DEVELOPMENT DETERMINATION PANEL MEETING

WEDNESDAY 11 SEPTEMBER 2024

ITEM 3.1 REV2024/0022 - 11 BRISSENDEN AVENUE COLLAROY - REVIEW OF DETERMINATION OF APPLICATION DA2023/0638 FOR DEMOLITION WORKS AND CONSTRUCTION OF A DWELLING HOUSE INCLUDING SWIMMING POOL AND STUDIO

REVIEW OF DETERMINATION ASSESSMENT REPORT

Figure 1: Amendments to north-western corner of the first floor

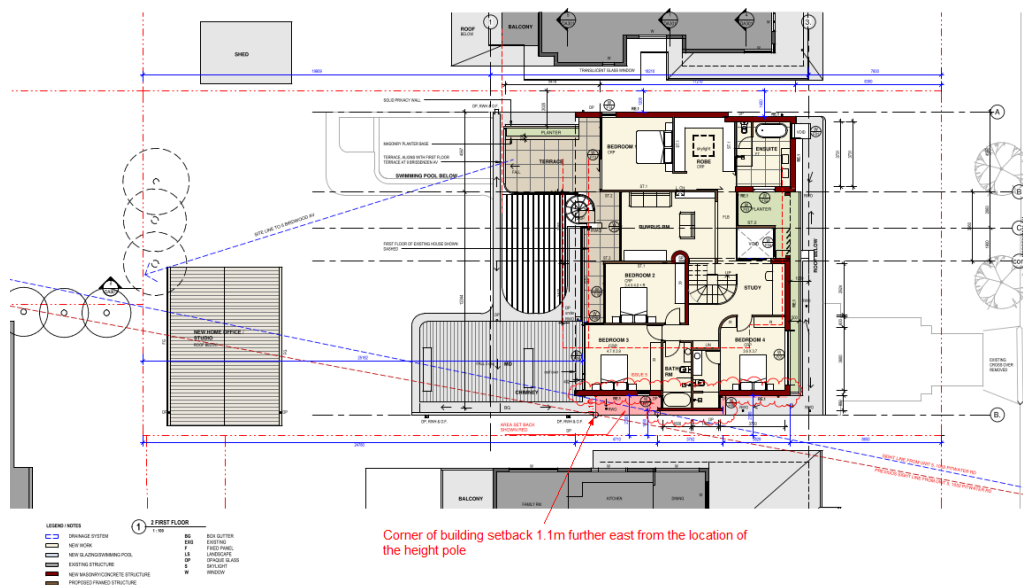
- The north-western corner of the first floor has been setback 1.1m further to the east of the previous development (see **Figure 1** below).
- The ridge height of the dwelling house has been increased from RL19.54 metres (m) Australian Height Datum (AHD) to RL19.76m AHD, which is a 0.22m increase.

The applicant has stepped the north-western corner of the first floor in approximately 1.1m further from the western boundary when compared to the plans refused under DA2023/0638. The extent of the numerical non-compliance to section B3 of the WDCP on the western elevation is 12.11%, which is acceptable from a building bulk and scale standpoint as the western elevation is sufficiently articulated. Notwithstanding, insufficient information has been provided with this application to demonstrate that the western envelope non-compliance will not result in adverse view loss from surrounding properties. A view corridor towards Collaroy Beach exists down the western side of the property and therefore, in the event that a loss of water views results from the western envelope non-compliance then this non-compliance would not likely be supported. Nonetheless, the applicant has not provided adequate information to demonstrate that the view loss impacts would be acceptable. It is noted that the west-facing bedroom window no longer protrudes outside of the side envelope requirement. Nonetheless, privacy attenuation measures should be incorporated to this window. This is assessed later within this report.

Figure 4: eastern envelope breach proposed under REV2024/0022 - no change to extent of non-compliance when compared to DA2023/0628 (numerical non-compliance still 35%)

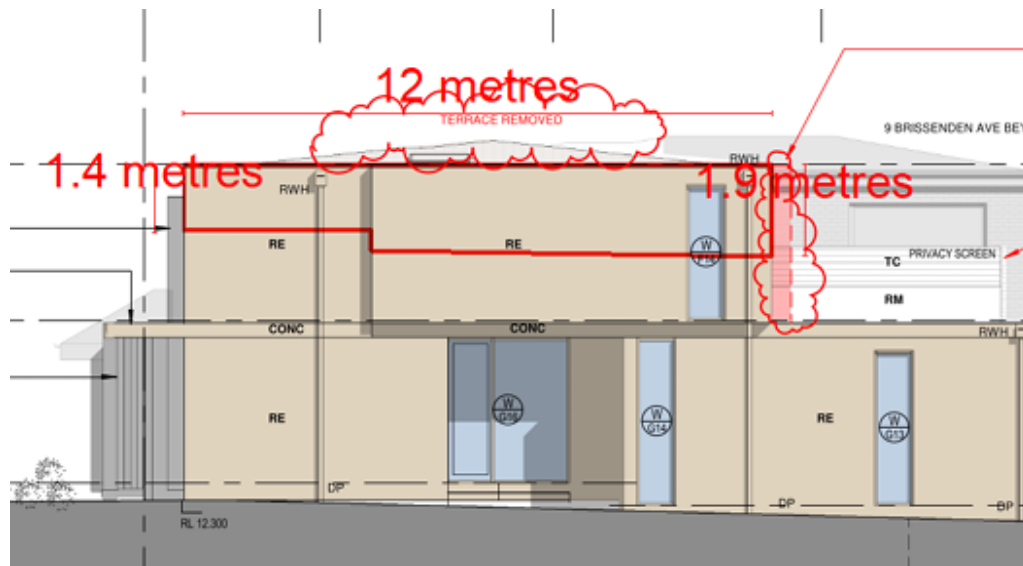
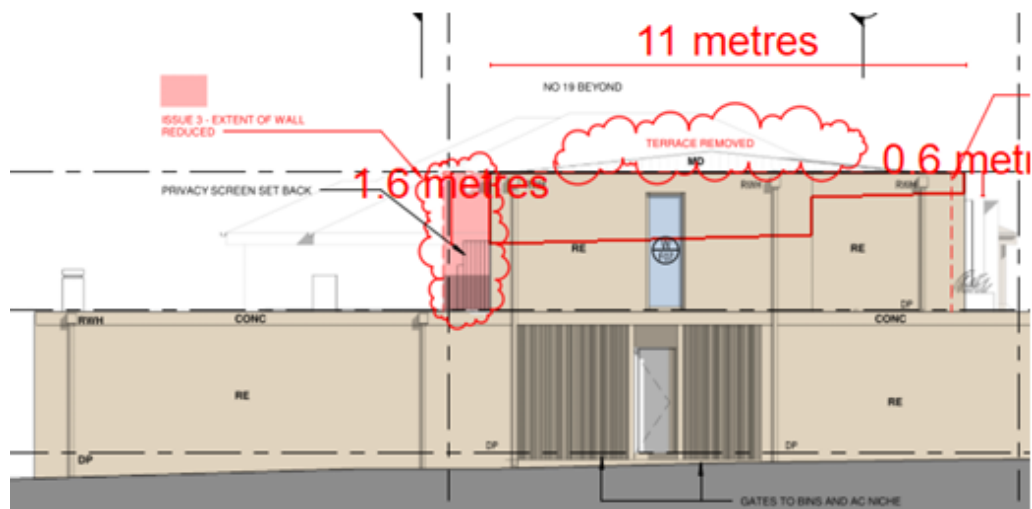
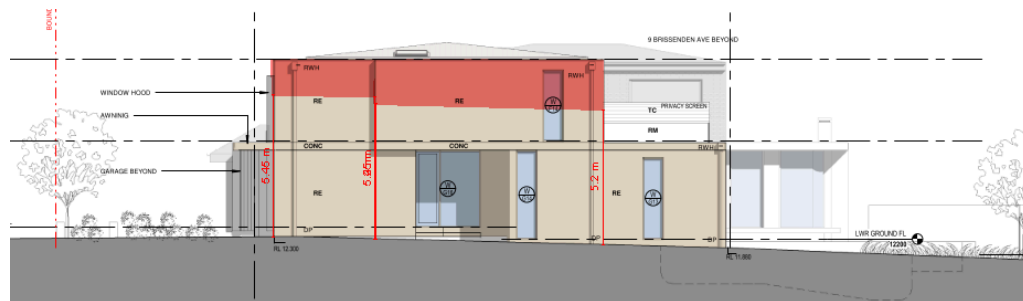
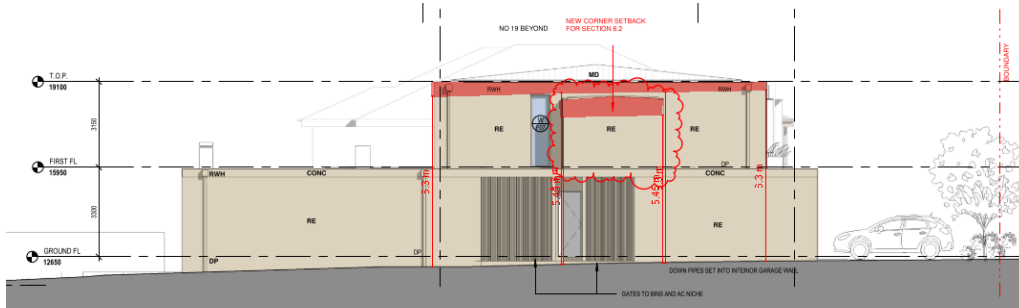
- The development remains significantly non-compliant with the side building envelope control prescribed by section B3 of the Warringah Development Control Plan 2011 (WDGP) on the eastern elevation of the dwelling house, representing a 35% variation to the numerical control.

As discussed within the section of this report relating to section 8.3 of the Act, the amended development proposed under the subject Review of Determination application (REV2024/0022) remains non-compliant with Part B3 of the WDCP. **Figures 2-5** below depict the extent of the non-compliance for the development refused under DA2023/0628 and the development proposed under REV2024/0022.

Figure 5: western envelope breach proposed under REV2024/0022 - extent of numerical non-compliance reduced when compared to DA2023/0628 (numerical non-compliance reduced from 33% to 12.11%)

The site is relatively flat. In this regard, the extent of the breach on the eastern elevation is not considered to be an appropriate response to the site topography. There are no environmental constraints, such as a steep slope or flooding constraints, that would result in a taller building. Hence, the development fails to achieve this objective.

Figure 2: Amended first floor location

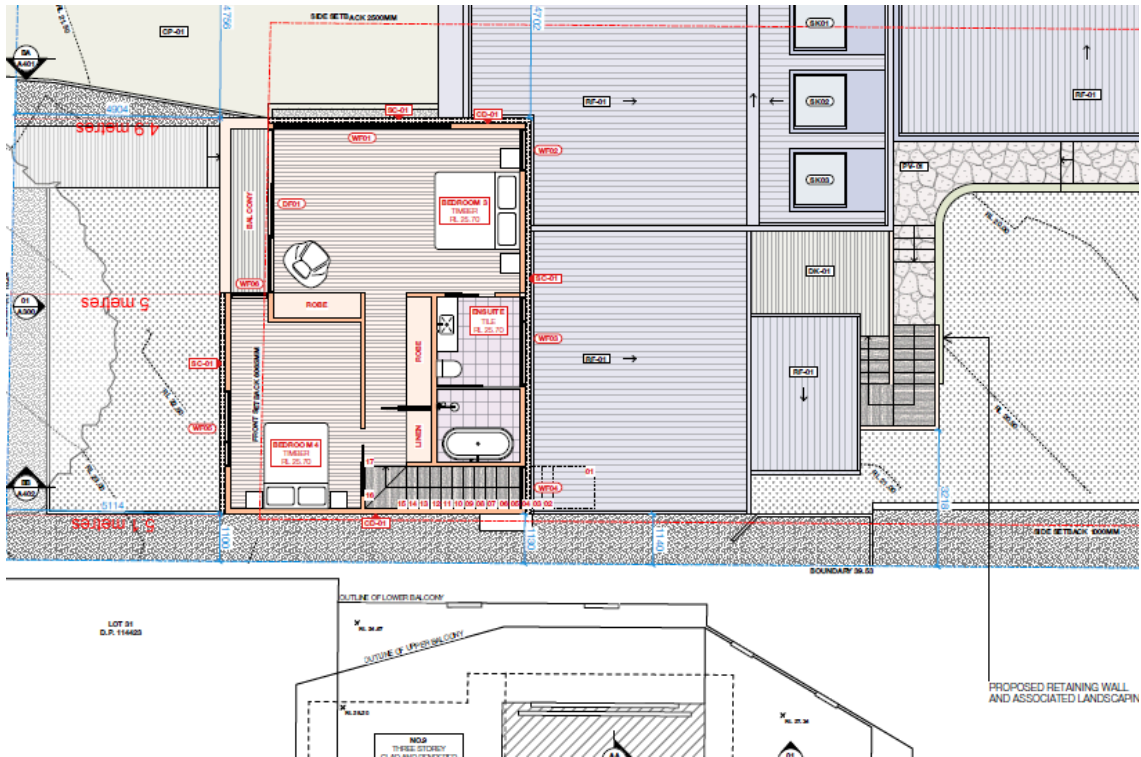
Following the receipt of amended plans, two (2) further submission were received in relation to view loss.

Figure 14: Building envelope non-compliance along the southern elevation

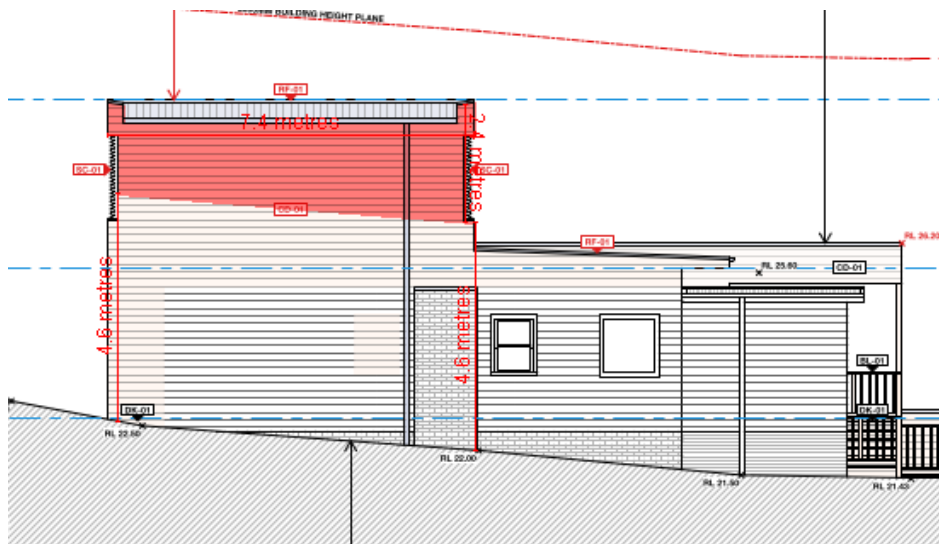
Clause D4.8 Building Envelope requires that built structures are sited within an envelope, measured at the side elevations of the dwelling by projecting planes at 45 degrees from a 3.5 metre height.

Figure 15: Building envelope non-compliance along the northern elevation

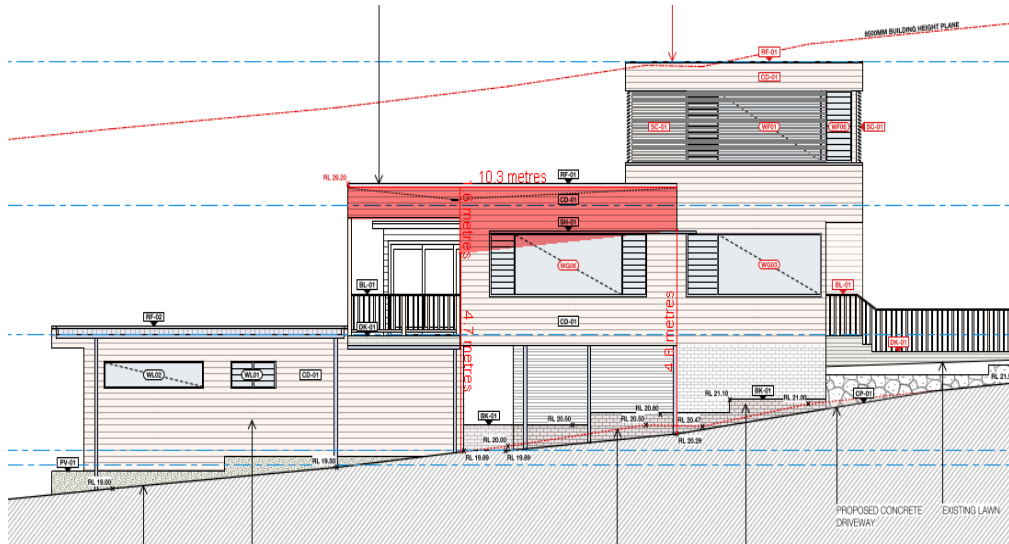
The proposed addition to the dwelling will form an encroachment on the northern elevation for a length of 10.3m at a maximum height of 1.6m.

Figure 1. Additional building bulk at the eastern elevation shaded red.

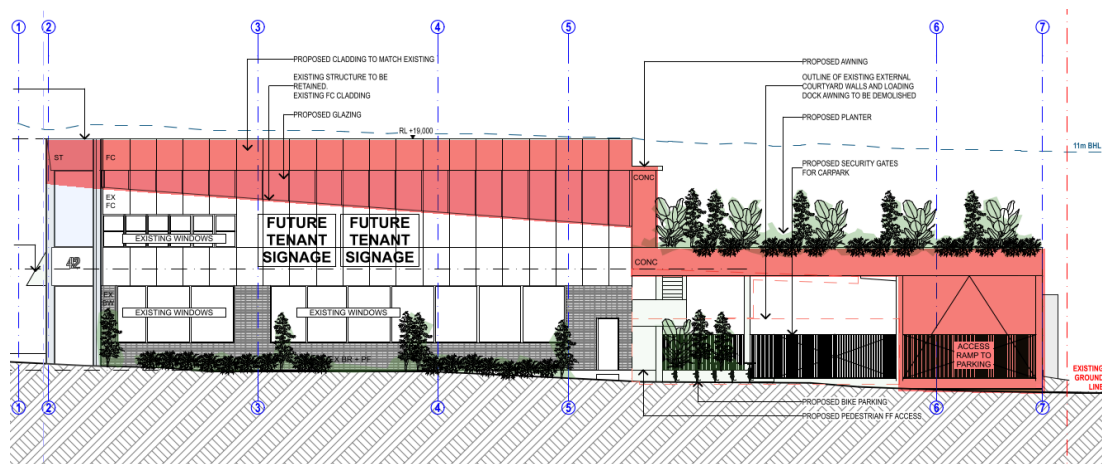
The proposal complies with requirements (b), (c) and (d), but does not comply with requirement (a) in relation to the proposed setback to Quirk Road. The extent of the proposed non-compliant works is illustrated below.
